35–039 Detroit New Final Drive Standard Performance Forward Carrier Change to Top Performance Passive Lube Management

TSB-35-039-FTL

Last Revision Date:2024-05-14

Description of Revisions: The bulletin replaces the version dated 01/26/2023. The oil specification has been updated.

Fig. 1, Original Standard Performance Carrier without a Lube Management System

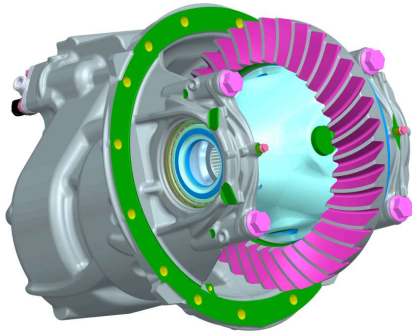
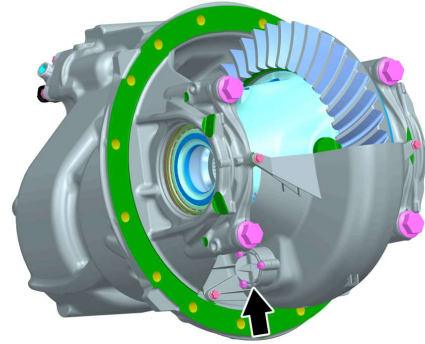
Detroit New Final Drive Standard Performance Axles will have a change to the lube management system. Initially launched without a lubrication management system, the forward rear axle will change to a passive management system. This will be the same passive lube management system as the New Final Drive Top Performance Axle with passive lube management.

The new Standard Performance carriers are backwards compatible, and will fit without modification into the same axle housing. It is okay to have the new carrier with passive lube management system in the forward carrier, and the original carrier in the rear carrier.

The parts will supersede in Excelerator. This change is happening to the forward-rear carrier only. See Fig. [1](#), Fig. [2](#) and Fig. [3](#).

Fig. 3, New Passive Lube Management Valve and Windage Tray

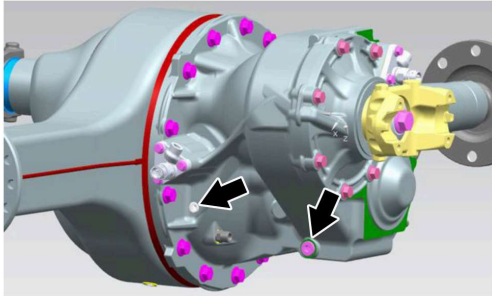
Oil fill locations will change to match the New Final Drive Top Performance locations. See Fig. [4](#). The type of approved oil is DFS93K219.01 only. The rear fill plug part number on the axle housing will change to a new part number (MBA 6809900117), and it will be installed from the inside, similar to the Top Performance carrier. See Fig. [5](#).
